Subject : 1. Reinforcement of elevator actuator bellcrank inside the fuselage.
2. Correction of the Operation Manual.

Effectivity : All ASW 15s and ASW 15 Bs including its variants as motorgliders.

ASW 15, ASW 15 B
Technical Note
No.22

Alexander Schleicher
Segelflugzeugbau
6416 Poppenhausen

Vertical fin spar

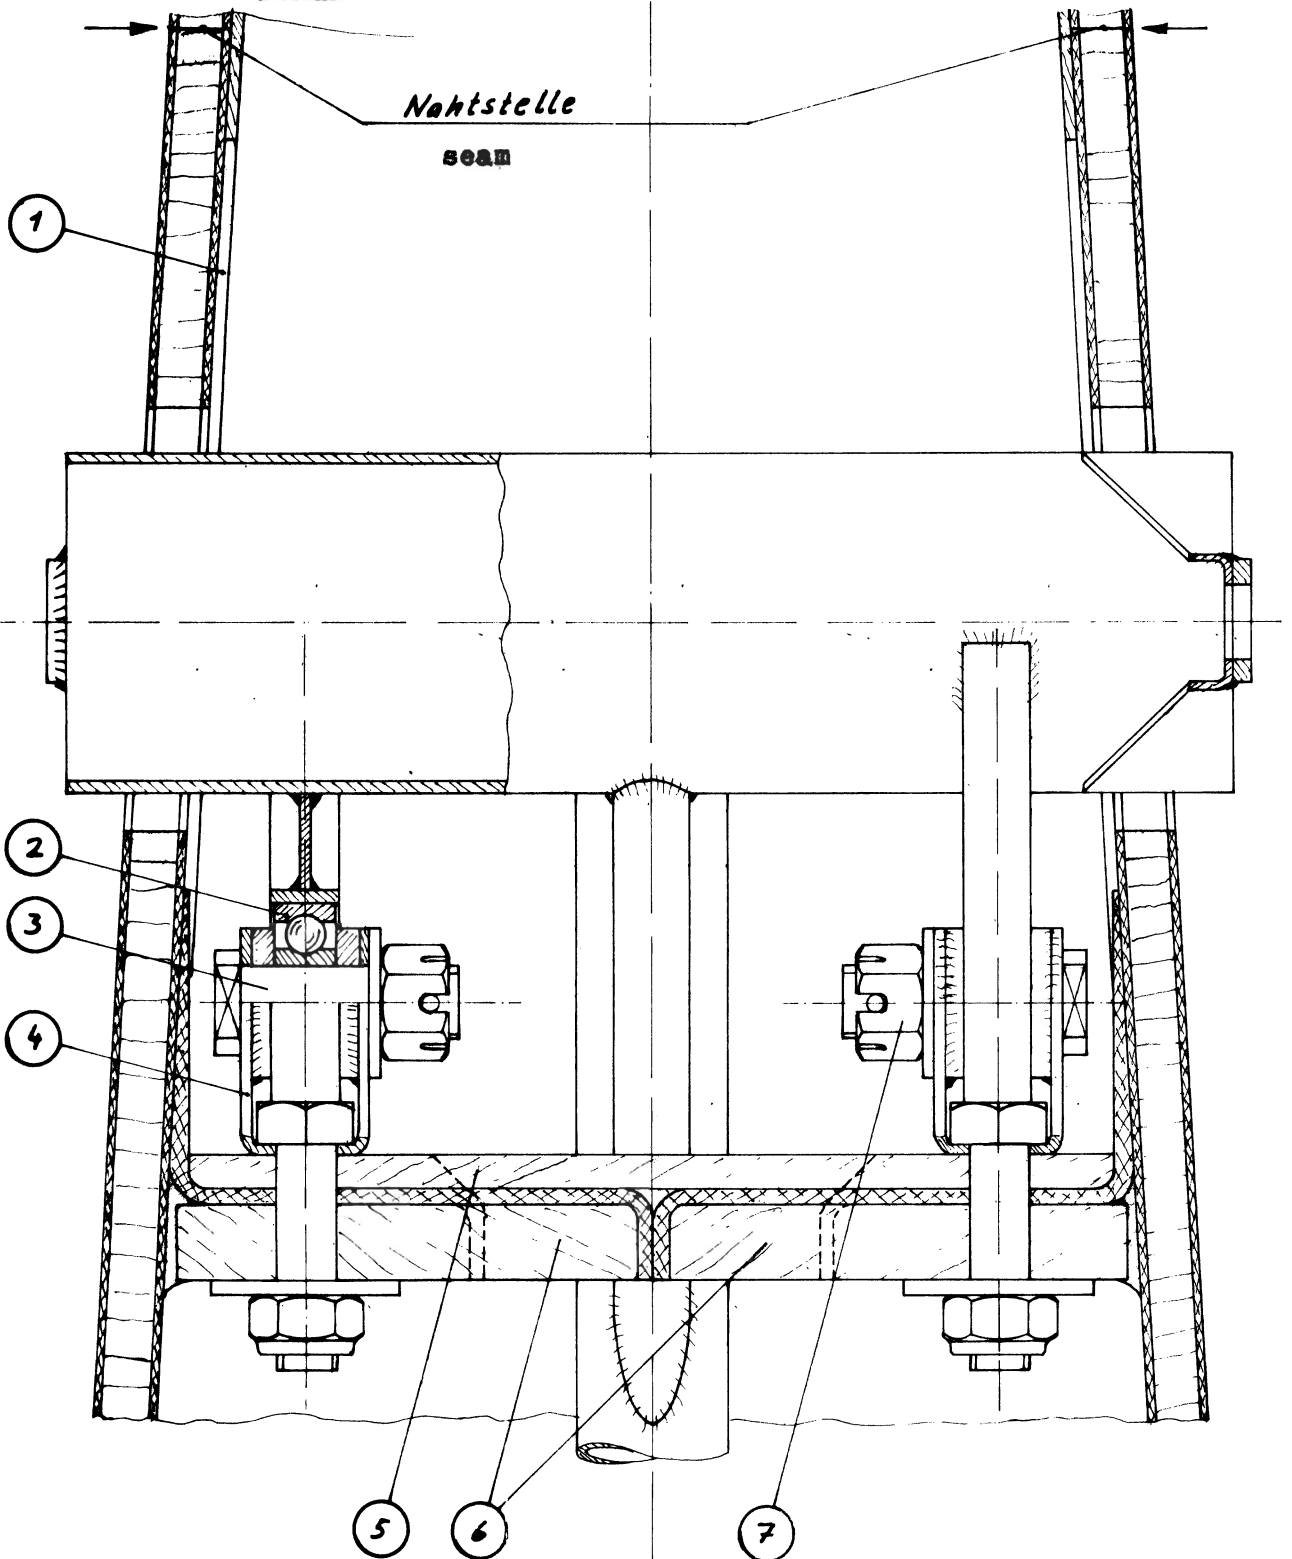
An additional piece of wood (see drawing sheet no.1 of this TN) is glued to the fin spar.

The openings in the spar are closed by overlap joint with plywood, 2mm thick, as can be seen on drawing sheet no.1; do not forget to preserve all internal surfaces before closing the openings.

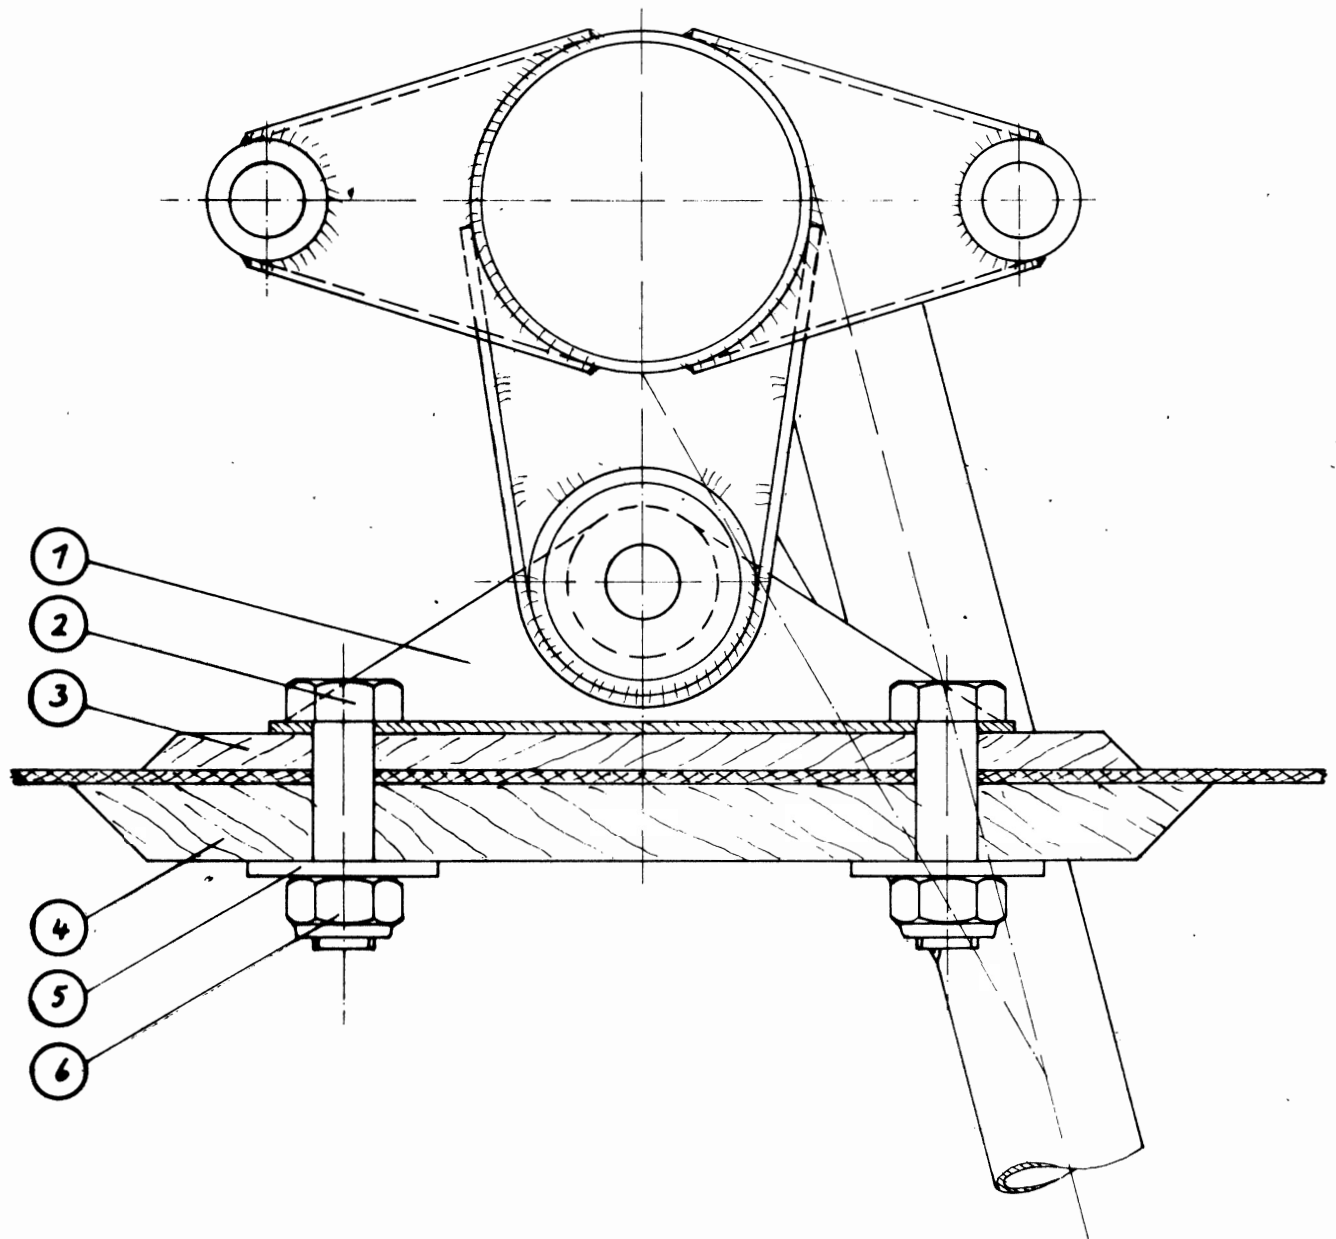
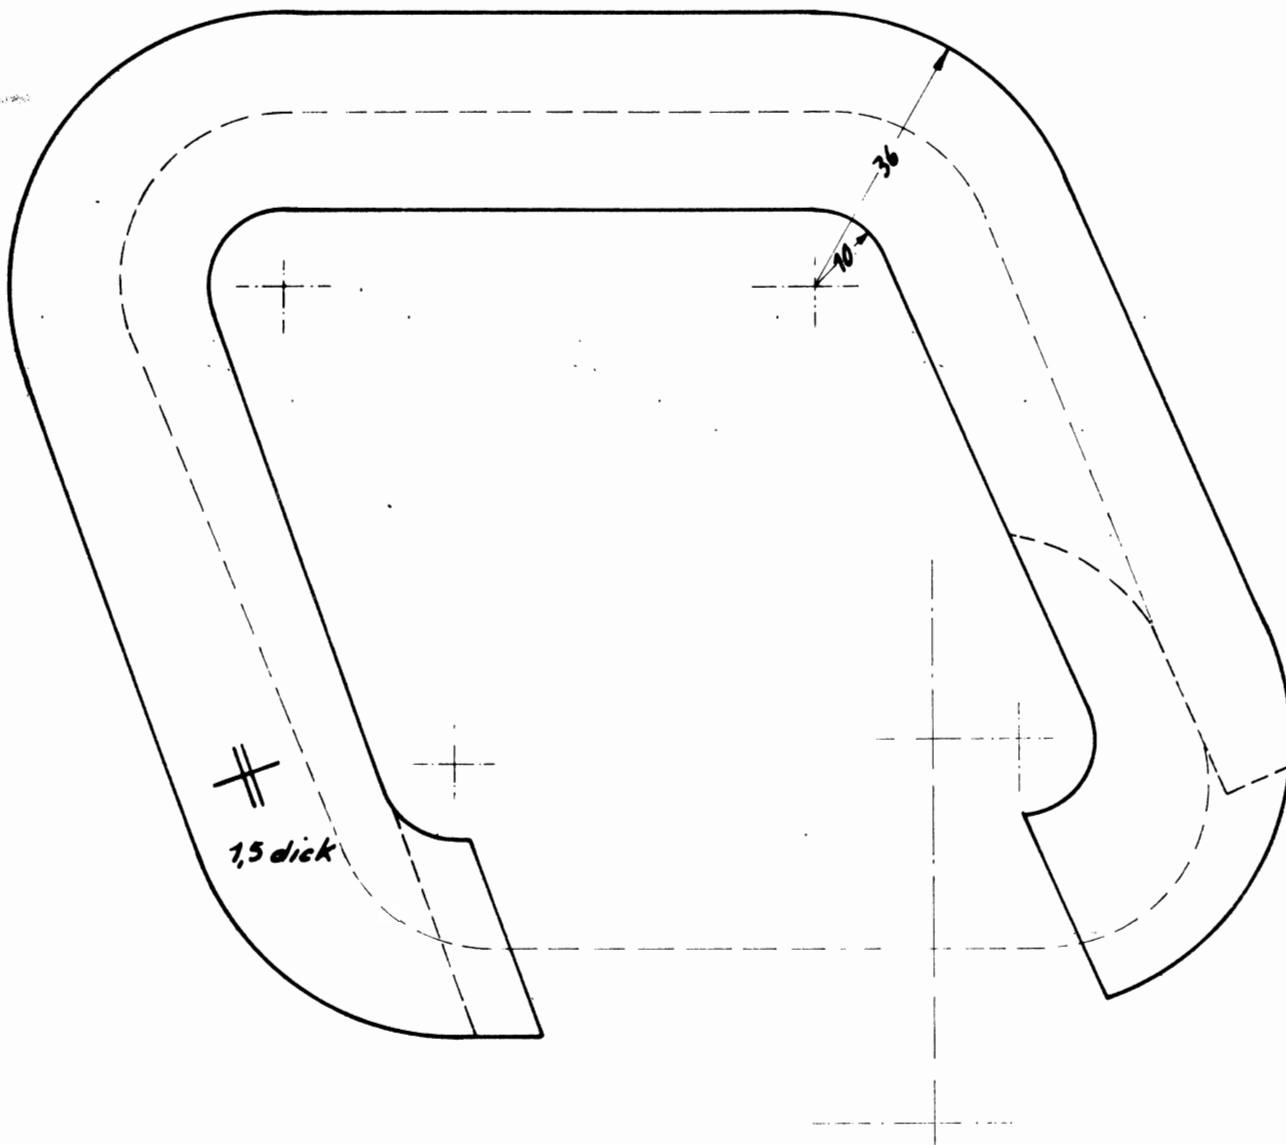
The plywood doublers at the fin root rib - if delaminated - have to be removed. If necessary, new plywood doublers (part no. 150.11.0170 and 151.11.0171, see drawing sheets no.5 and 6 of this TN) have to be fitted in according to drawing sheets no. 2 and 3. Using the existing holes in the FRP rib new holes must be marked on the ply then must be drilled exactly and preserved with resin/hardener mixture before being fitted in.

It is recommended to use the stronger, reinforced doublers, part no.151.11.0171, on the lower side of the fin root rib for ASW 15 (serial numbers 15001 through 15183) - if these have not already been replaced on earlier occasions.

Drawing sheet no. 7
 Number of sheets: 11

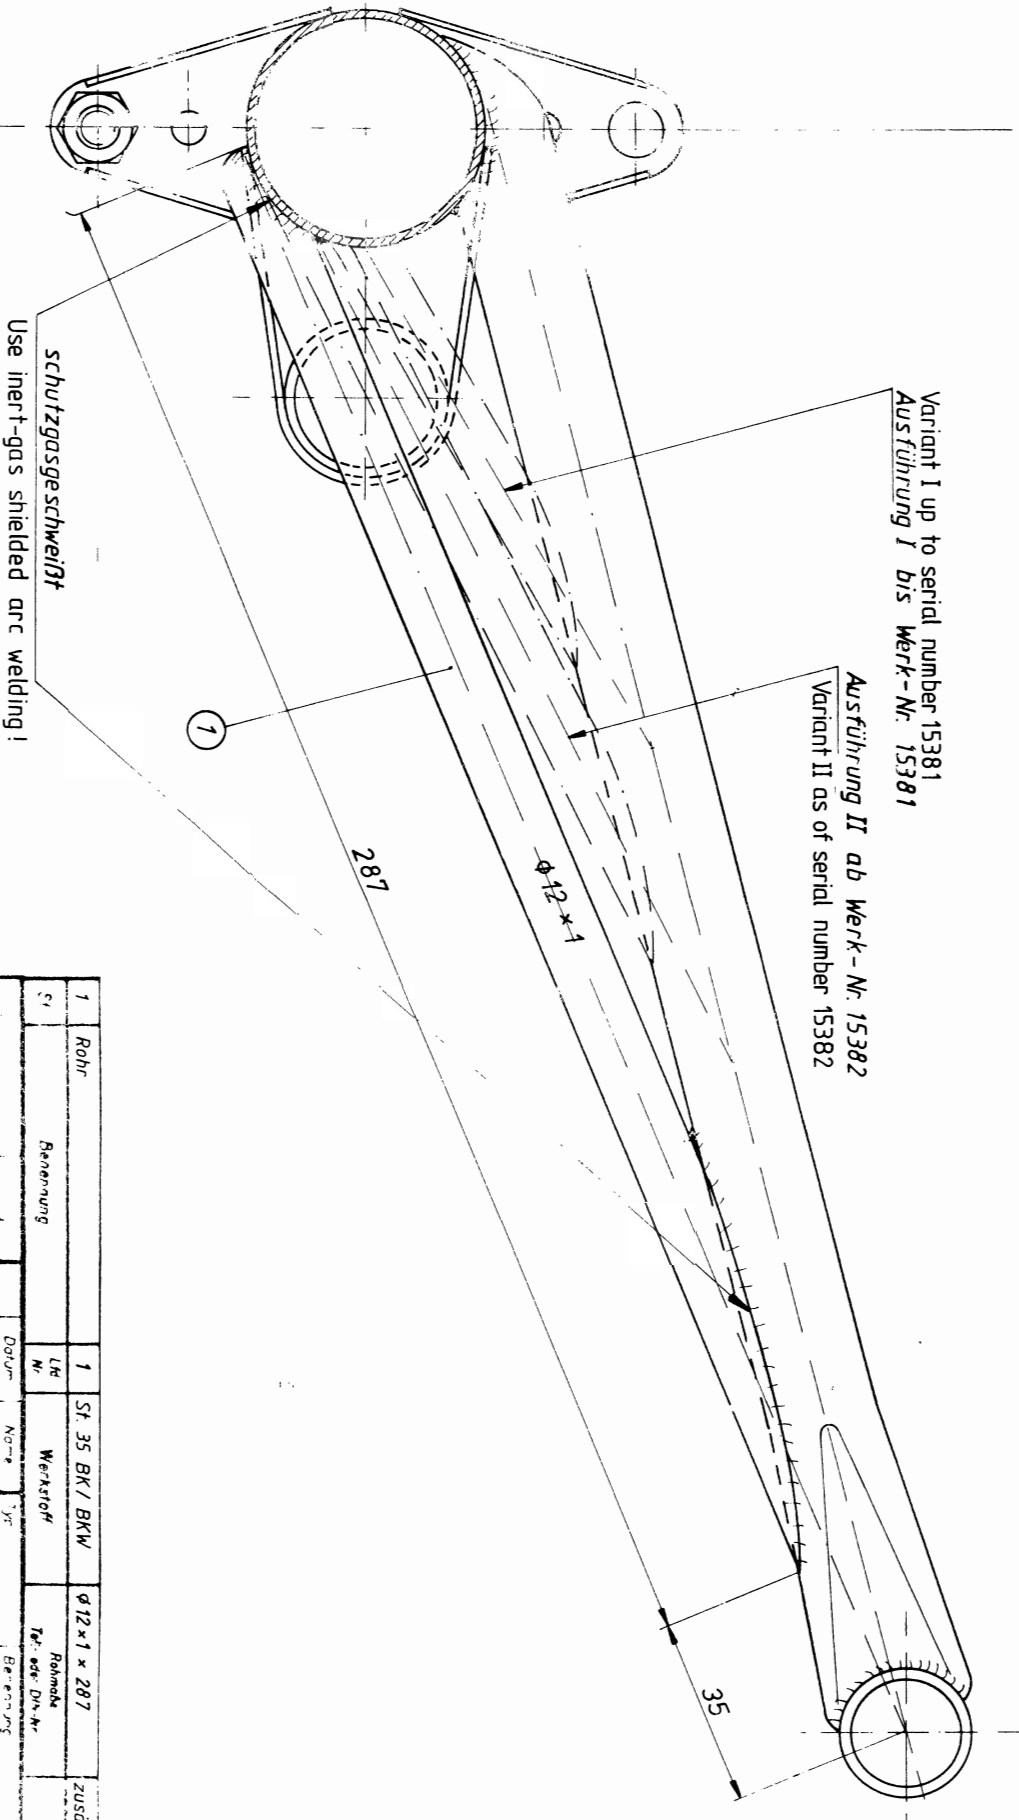
The elevator actuator bellcrank itself must be reinforced by an additionally installed tube ($\emptyset 12 \times 1$; steel St35BK or BKW) according to drawing sheet 151.35.1011 Ausführung IV (version IV). To do this properly, the paint has to be removed carefully at the welds (e.g. by sandblasting).

To guarantee minimum welding deformation (shrinkage) inert-gas shielded arc welding by use of 1.7324.0 welding wire must be applied. The ball bearing at the low end of the bellcrank needs not to be removed and a readjustment of the elevator control circuit is usually not necessary.

For this TN the drawing no.151.35.1011 "Ausführung IV" (version IV) has been made (see drawing sheet no.7 of this TN).

Ausführung IV
Variant IV

schutzgassgeschweißt
 Use inert-gas shielded arc welding!
